# Groundwater Transfer Review Summary Form

Transfer/PA # T- 14791

Application: T-14791

Applicant Name: Cook Landholdings, LLC

# T-14791 Cook Landholdings, LLC.

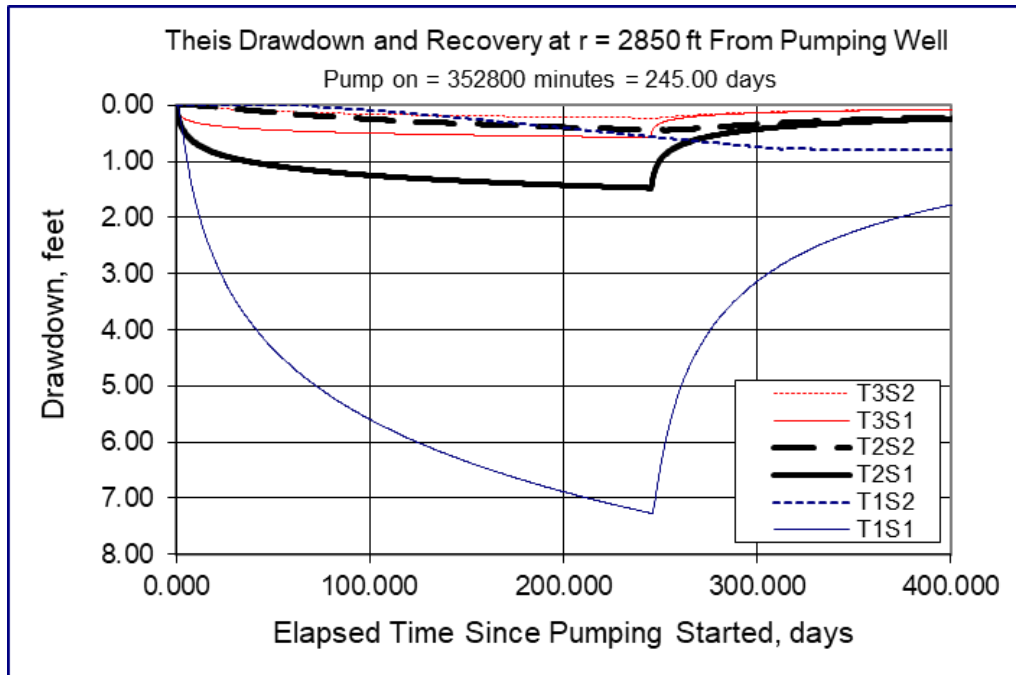
5. a) Will this proposed change, at its maximum allowed rate of use, likely result in an increase in interference with **another ground water right**?  
 Yes    No   Comments: The APOA, Well 3 (NLOG 58045), is closer to LINN 5302, is authorized for irrigation per Claim GR-712 with priority date 2/28/1947. The reduced intervening distance is likely to result in an increase in interference with LINN 5302.

Yes  No Comments: The APOA, Well 3 (NLOG 58045), is closer to SW 1 (McCarthy Slough). The reduced intervening distance is likely to result in an increase in interference with SW 1 (McCarthy Slough).

Stream Depletion Analysis: Well 3 (NLOG 58045)-McCarthy Slough

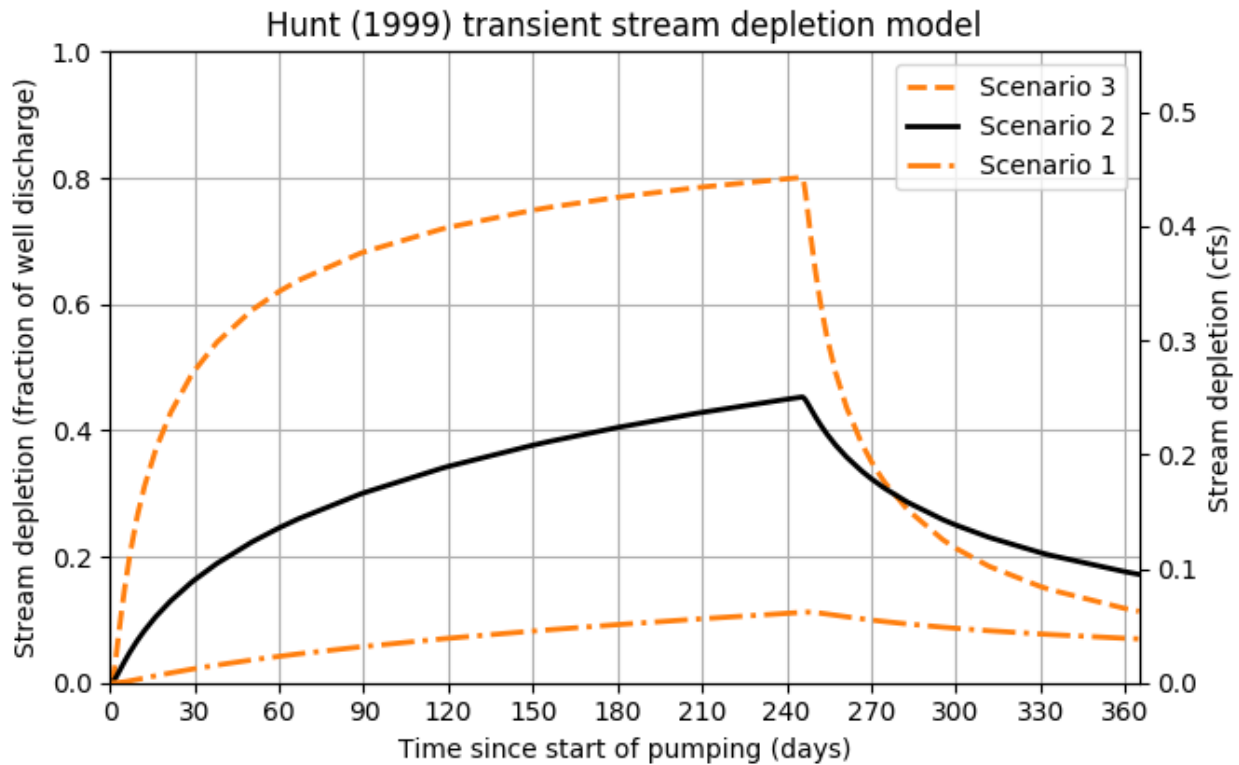
Provide context for minimal/significant impact: The expected increase in depletion from McCarthy Slough was assessed using the Hunt (1999) analytical model for stream depletion due to pumping in an unconfined aquifer (see attached Stream Depletion Analysis). Results indicate that stream depletion due to pumping could likely increase by 3% of the rate of withdrawal after 245 days of continuous pumping as a result of the proposed change. Assuming that the APOA, Well 3 (NLOG 58045), was to pump at the maximum rate of 0.553 cfs (248 gpm)\* over the full 245 days, the proposed change could result in an additional 0.129 cfs (57.9 gpm) of depletions to McCarthy Slough by the end of the irrigation season. McCarthy Slough is within WAB #183 with the lowest month of natural stream flow in August; the Net Water Available in August is 990 cfs. The change in degree of interference with McCarthy Slough by the APOA, Well 3 (NLOG 58045) is anticipated to be minimal.
